SERVICE INSTRUCTION M20-105

DATE: 21 APRIL, 2000

SUBJECT: ENGINE MOUNT INSPECTION/REPAIR, COWL FLAP MODIFICATION

FIGURE SI M20-105-1

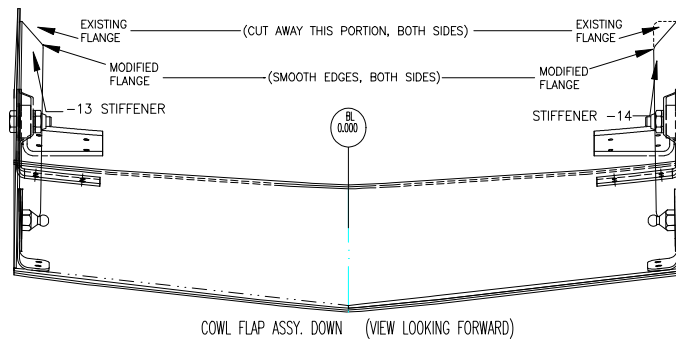
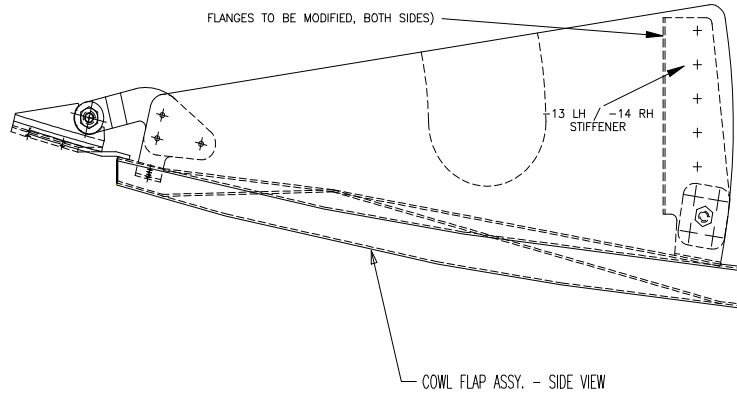
7. Disconnect cowl flap from linkage mechanism on both sides of cowl flap. Let cowl flap hang down for access.
8. Mark a 45° angle on the upper, top, tip end of the stiffener angled flanges, both sides of the cowl flap, from the flange bend radius area to the outside edge of the flange.
See Figure SI M20-105-1.
9. Carefully cut this marked portion from the stiffener flange of each stiffener on the cowl flap assembly.
10. Burnish the cut edges, especially in the flange's bend radius area. Radius the outer edge of the flanges with a file to approximately a 1/8 inch outside radius.

11. Re-attach the extension/retraction linkages to the cowl flap. Run cowl flap to the UP (closed) position and observe the proximity of the cowl flap stiffener flange to the engine mount. The modification should provide sufficient clearance between the engine mount and the cowl flap during flight, even though an interference point cannot be identified in the static position.
12. Re-install cowling onto aircraft (if removed). Connect retract/extend linkages to cowl flap.
